Project Name: Riverside & Broadway Target

DESIGN COMMISSION COMMENTS

Project Name: Riverside Target
File Number: DR08-074
Owner: Target - John Dewes
Date of Notice: June 26, 2008
Staff Contact: Matthew Sites, Associate AIA, 916-808-7646

June 26, 2008
Attachment 2: Building cross-section

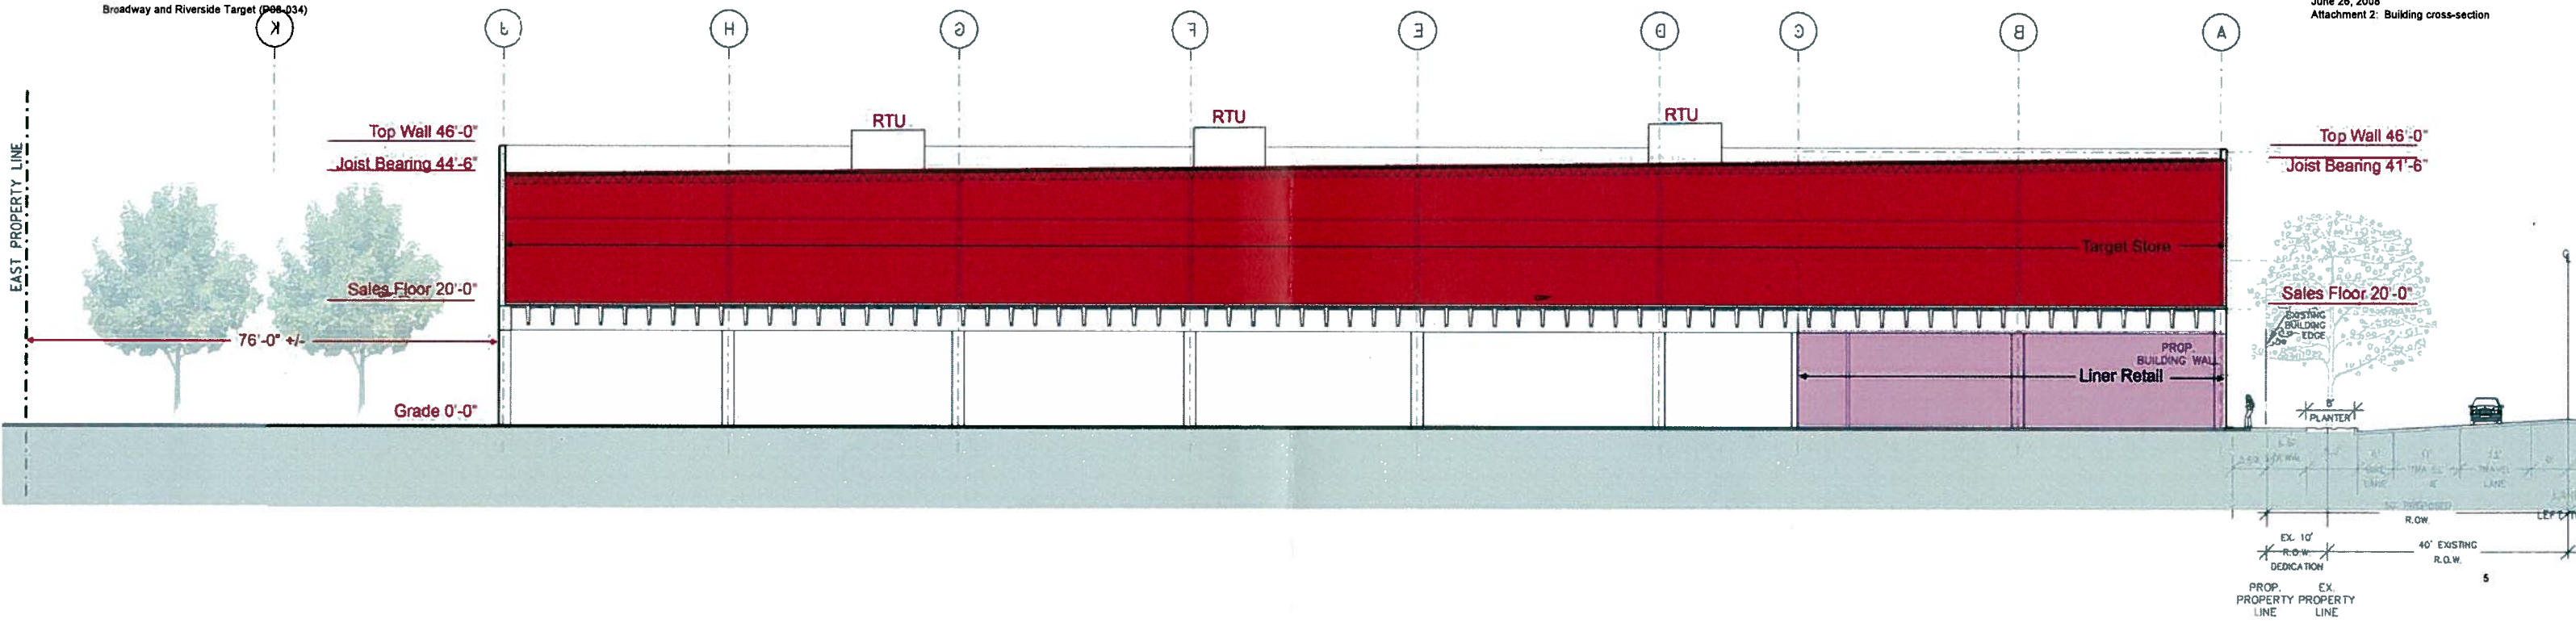
Staff is revising the report so that all references to the buildings height are changed from 48 feet to 46 feet. Attachment 2 shows the building cross-section, demonstrating the height.
